# Making Sense out of ILT

IEEE 802.3dj Joint Ad hoc Mtg – 05 Jun 2025

# Graphical View - ILT Specification Methodology (D2.0)

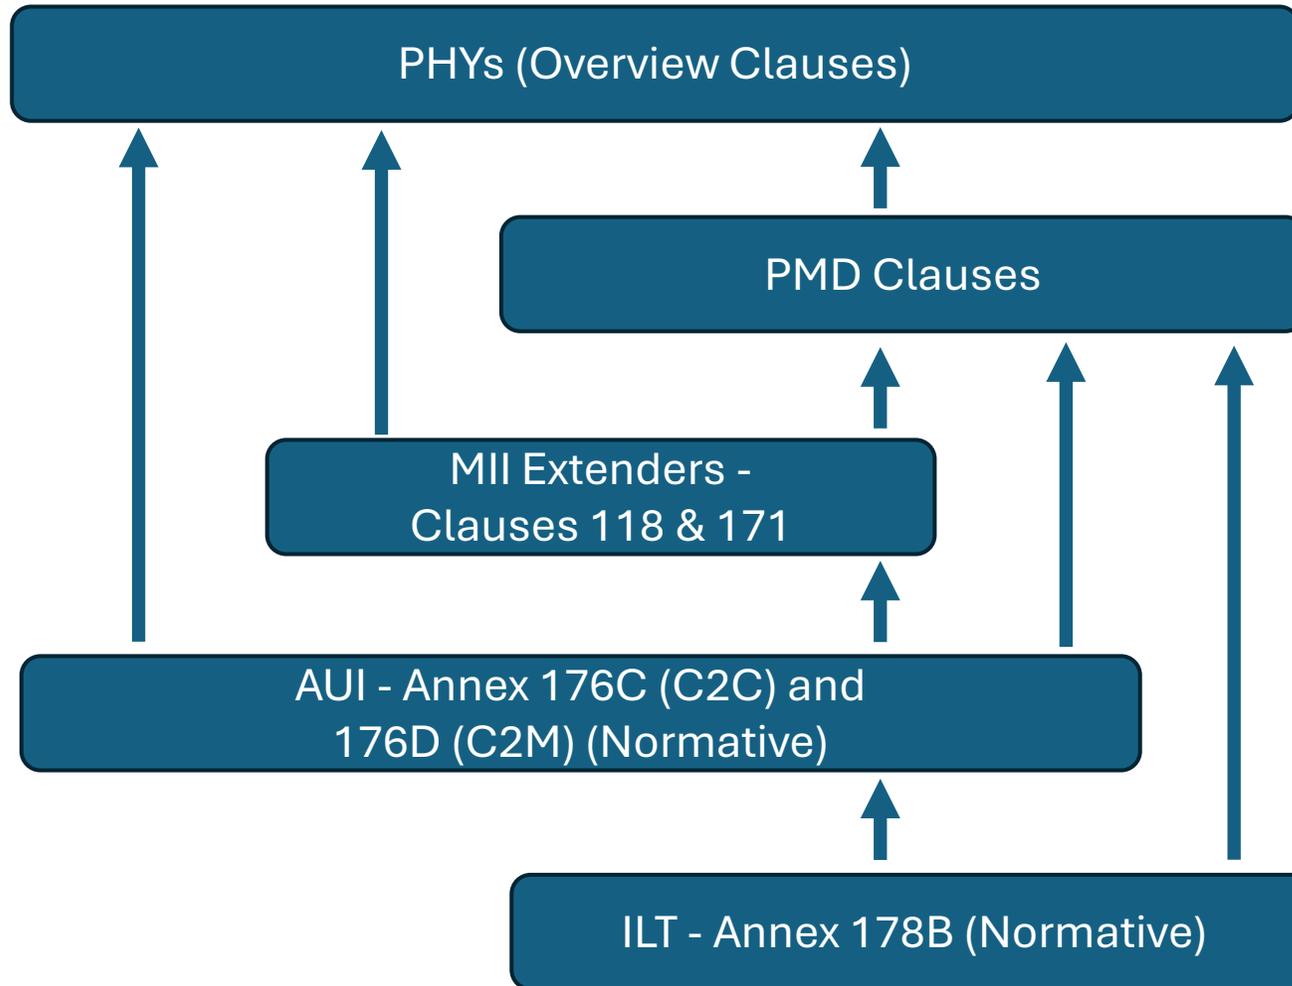
Introductory clauses summarize PHYs that support ILT: 116.2.9, 169.2.10, 174.2.12 (See next page)

Subclauses specifies normative support of ILT for PMD:  
KR - 178.8.9; CR - 179.8.9; DR - 180.5.12; DR-2 - 181.5.12;  
FR-500 - 182.5.12; FR4 / LR4: 183.5.12

For MII Extenders, normative specificizes:  
Table 118-a : 200 Gb/s based AUI's > 200GMII Extender  
Table 118-b: 200 Gb/s based AUI's > 400GMI Extender  
Table 171-1: 200 Gb/s based AUI's > 800GMII Extender  
Table 171-1a: 200 Gb/s based AUI's > 1.6TMII Extender

176C.3 Functional specification - "... a C2C component shall provide the inter-sublayer link training (ILT) function..."  
176D.3 Functional specification - "... a C2M component shall provide the inter-sublayer link training (ILT) function..."

Normative specifications  
"178B.4 ILT function in AUI components and PMDs"
